**AMENDMENTS TO THE DRAWINGS:**

## REMARKS

FIG. 1(PRIOR ART)

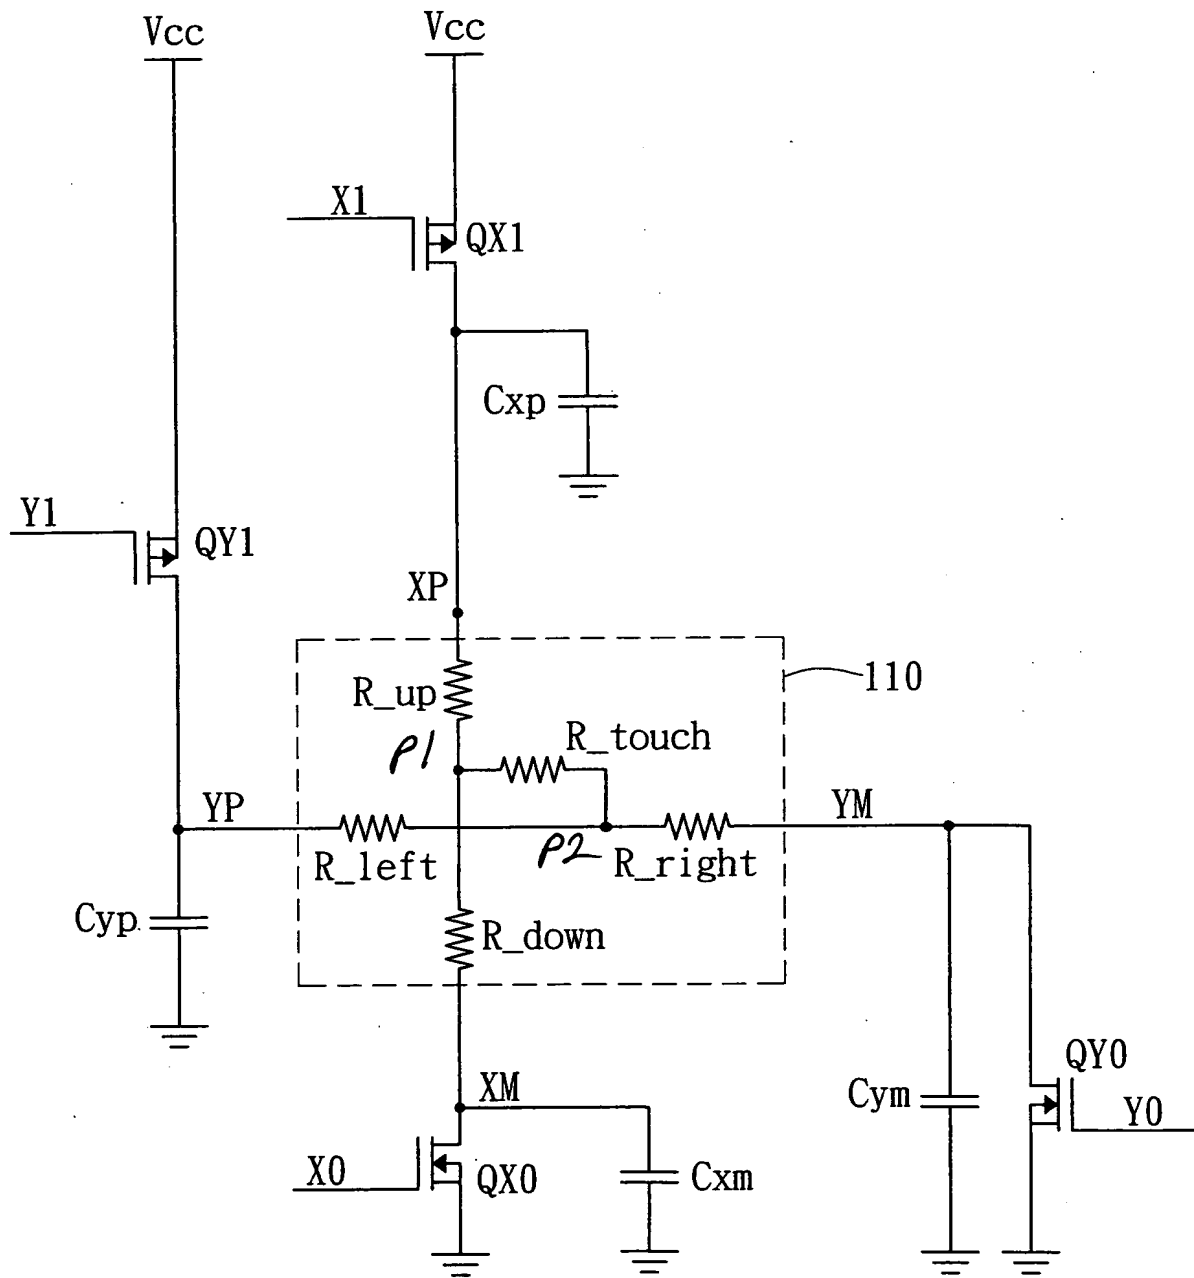
In the drawings, Figs. 1, 2A, and 2B are amended to add the labels “P1” and “P2” at each end of resistor “R<sub>touch</sub>,” and Fig. 5 is newly added.
